RE: Lot 7 Block 7 Unit 5 S.A.D. 227 7911 Kibo Rd. NW Grading and Drainage Plan Engineers Stamp Date 3/28/19 (E10D060)

RE: Lot 7 Block 7 SAD 227 Unser Cliffs 7911 Kibo NW Grading and Drainage Plan Engineers Stamp Date 3/28/19 (E10D060)

Based upon the information provided in your submittal received 3/28/19, this plan cannot be approved for Grading Permit until the following comments are addressed.

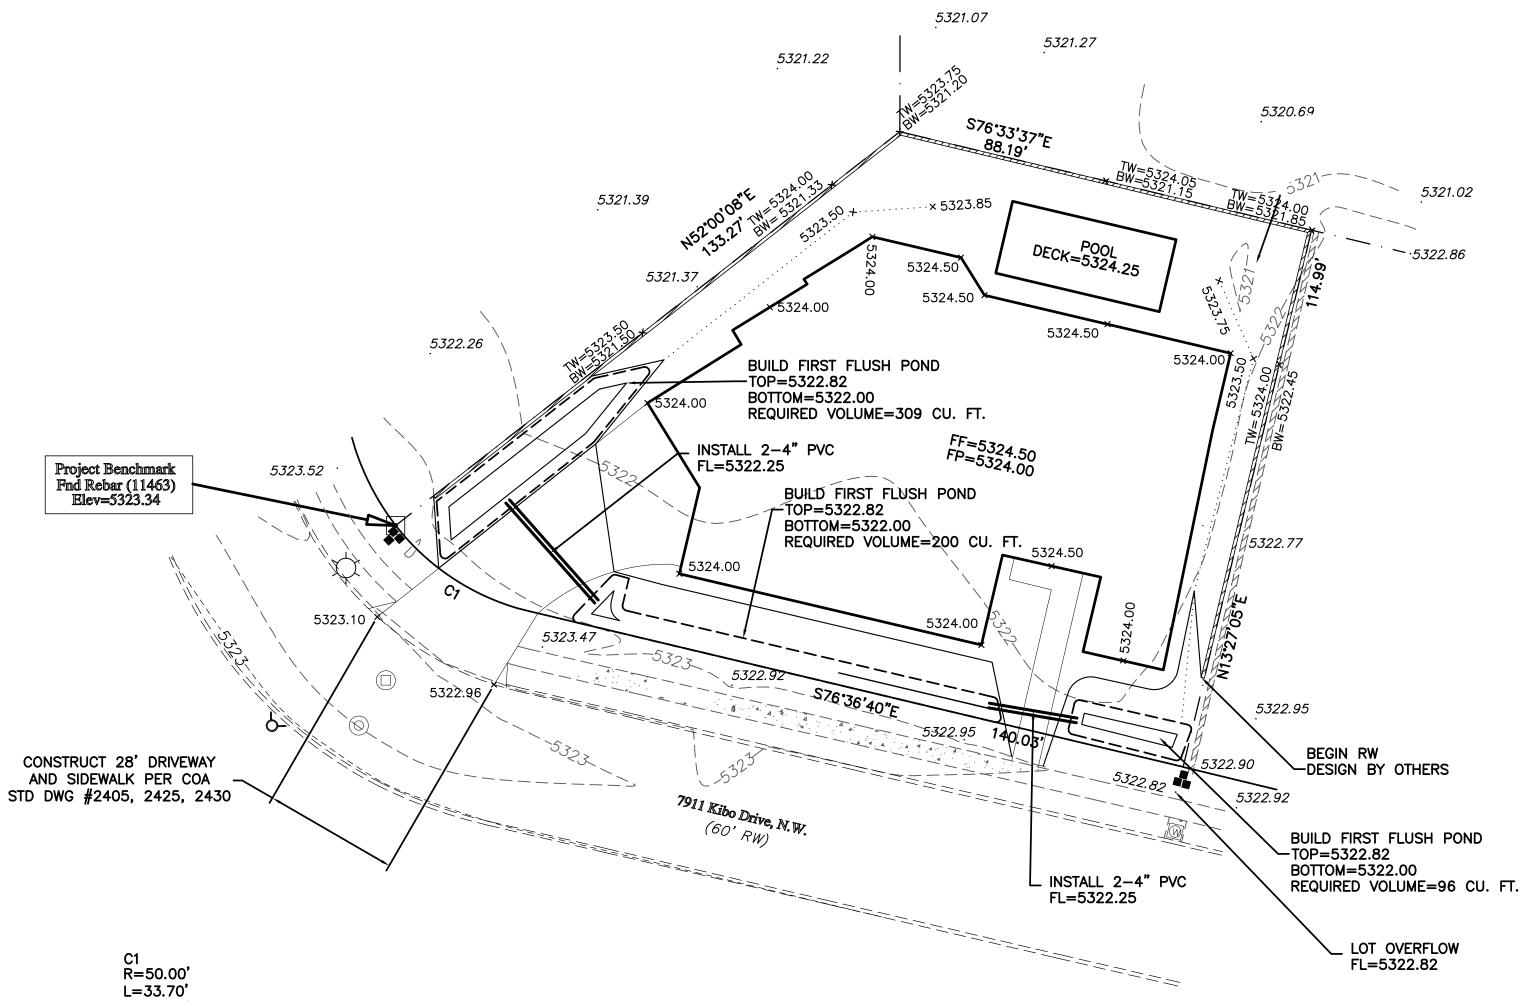
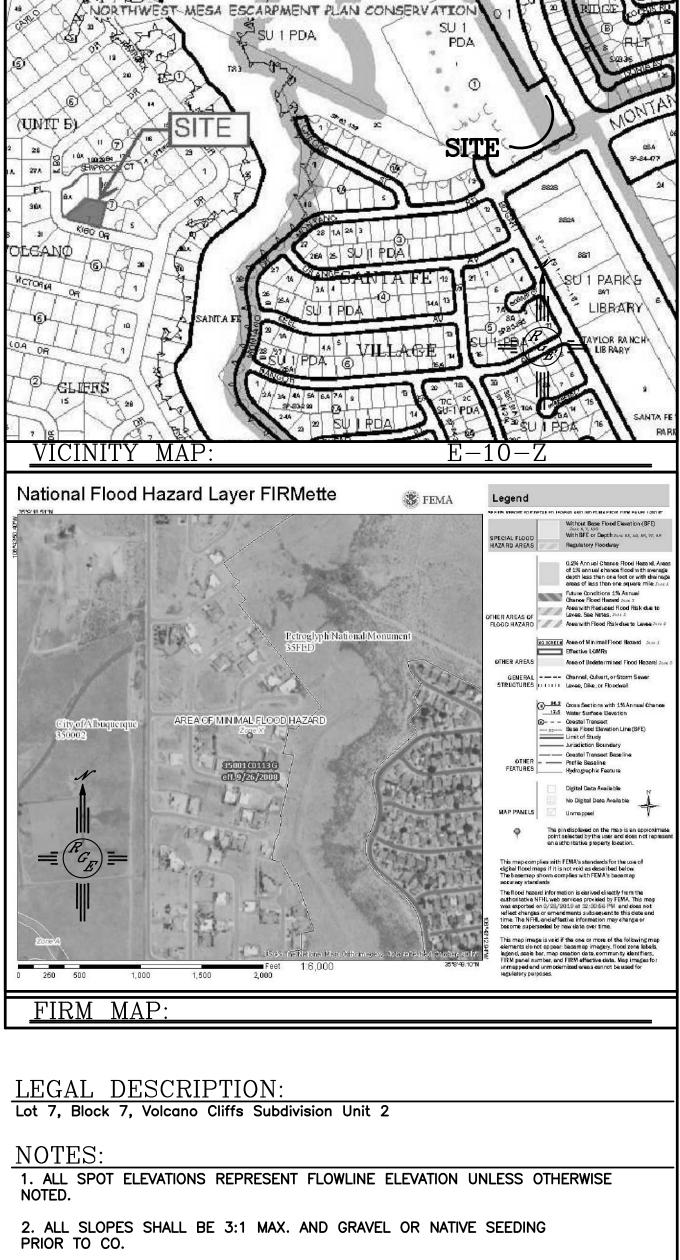
• Provide a detention pond for the site. The percentage required is 34%, the amount of D provided is 58%, the pond must contain the difference which is 24%.

WE HAVE UPDATED THE CALCULATIONS, THE PROPOSED PONDING EXCEEDS REQUIRED Prior to Building Permit approval a pad certification is required.
